ILLINOIS POWER COMPANY

Subject: Clinton Power Station Unit 1
SER Confirmatory Issue No. 71
Humphrey Concerns

Action Plan 2 (Revised)

Figure 3-2: ENCROACHMENT MODIFICATION FOR CLINTON

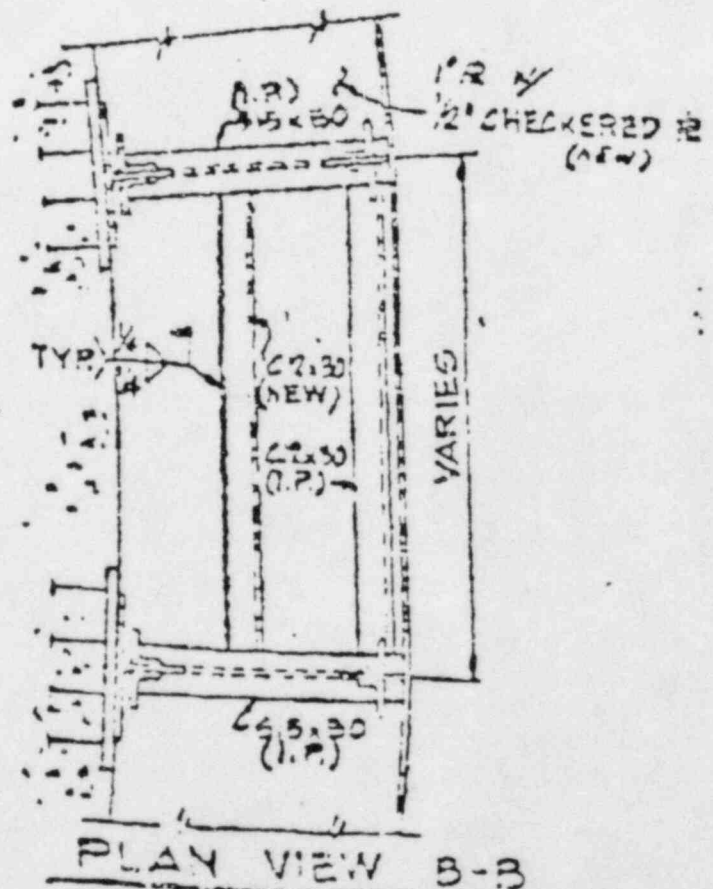
- 1.5 Impact loads on the HCU floor may be imparted and the HCU modules may fail which could prevent successful scram if the bubble breakthrough height is raised appreciably by local encroachments.

A new SOLAV01 analysis was performed in response to a design change to the encroachment of the CPS suppression pool. The encroachment was increased by replacing the existing grating with 1½" steel plate, as shown in Figures 3-1 and 3-2. The plate extension has the effect of diverting the water toward the outer portion of the containment, which prevents water slug impact on the HCU floor. Loads for various structural members of the HCU floor over the equipment and personnel hatches were calculated using FSAR pressure histories.

Figures 3-1 and 3-2 show the plate modification which extends three feet radially beyond the equipment hatch and personnel hatch, respectively. SOLAV01 predicts the worst-case pool swell to occur at the midpoint of the circumferential cross section of the encroachment that is the furthest from the clean pool.

Figure 8.1. Schematic of Clinton RHR Heat Exchanger

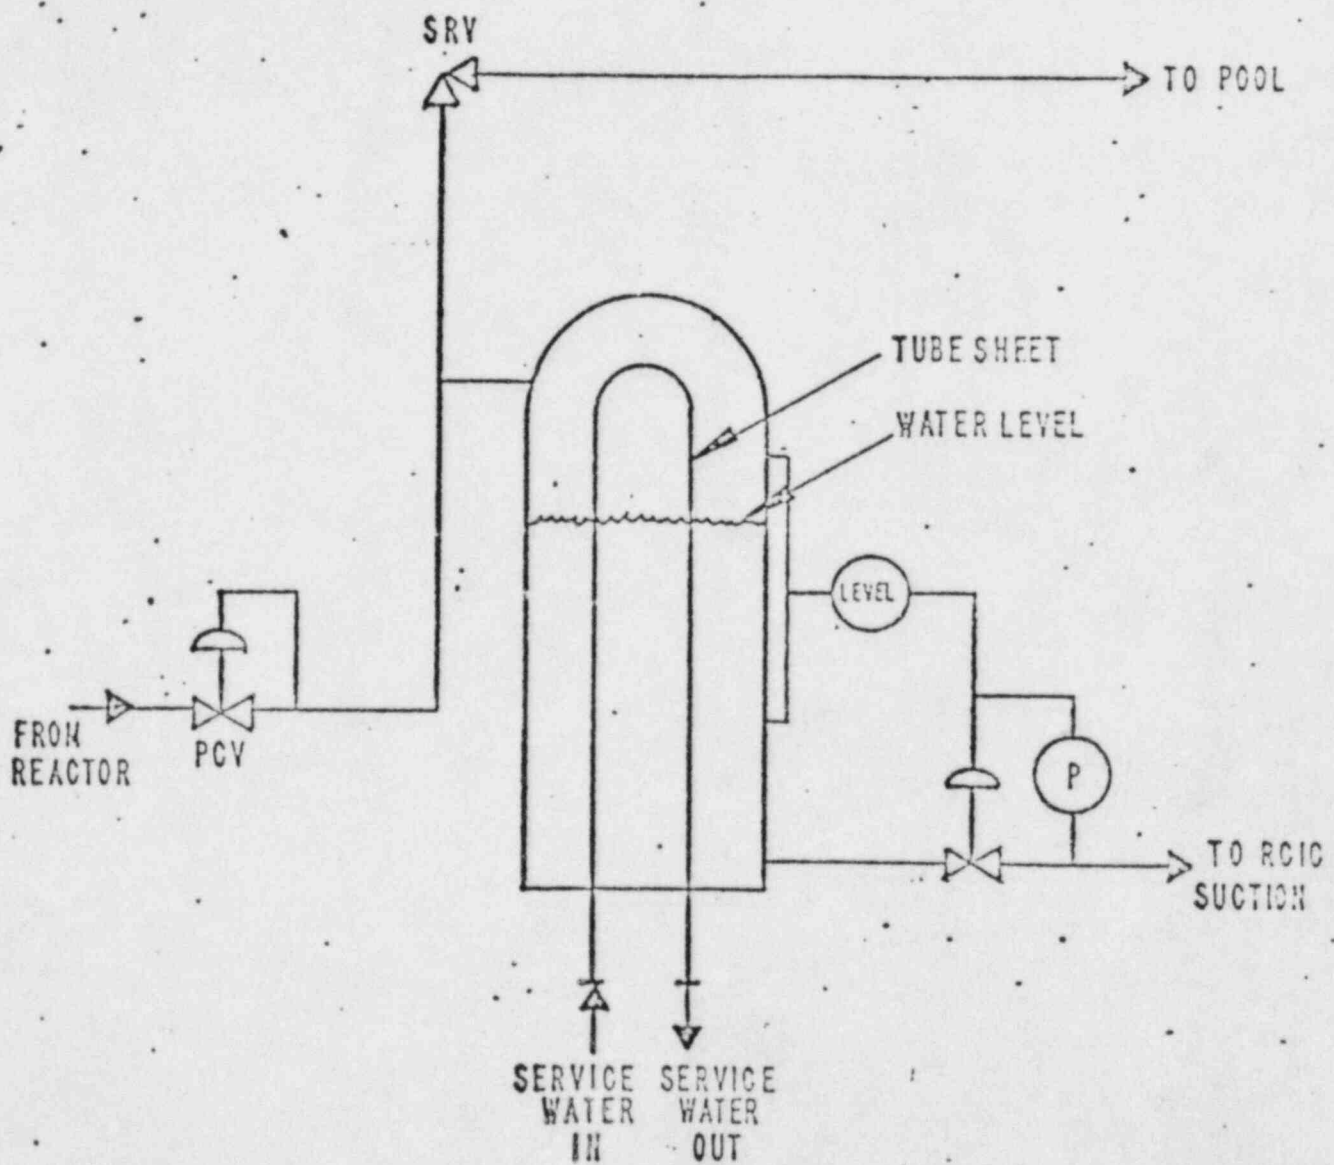
- 3.4 The RHR heat exchanger relief valve discharge lines are provided with vacuum breakers to prevent negative pressure in the lines when discharging steam is condensed in the pool. If the valves experience repeated actuation, the vacuum breaker sizing may not be adequate to prevent drawing slugs of water back through the discharge piping. These slugs of water may apply impact loads to the relief valve or be discharged back into the pool at the next relief valve actuation and apply impact loads to submerged structures.
- 3.5 The RHR relief valves must be capable of correctly functioning following an upper pool dump which may increase the suppression pool level as much as five feet creating higher back pressures on the relief valves.

A schematic of the RHR in SCM is shown in Figure 8.1. The steam flow into the RHR heat exchanger is controlled by a pressure control valve (PCV) that is set to maintain a desired pressure in the RHR heat exchanger. The Clinton Power Station RHR system design does not have non-condensable bleed lines running between the RHR heat exchangers and the relief discharge lines. This fact makes the Clinton RHR system design different from both Perry and Grand Gulf designs. The only way that steam flow into the Clinton RHR relief discharge line can occur is through the safety relief valves (SRV) that are provided to prevent over-pressurization of the RHR heat exchangers. The various scenarios leading to steam flow through the discharge line are discussed below.

In this scenario it is postulated that a mechanical failure of the PCV (see Figure 8.1) occurs and it pops open as soon as the steam block valve from reactor is opened. The RHR heat exchanger will pressurize rapidly to the SRV set point. At this point, the SRV will open and discharge steam to the suppression pool through the discharge line.
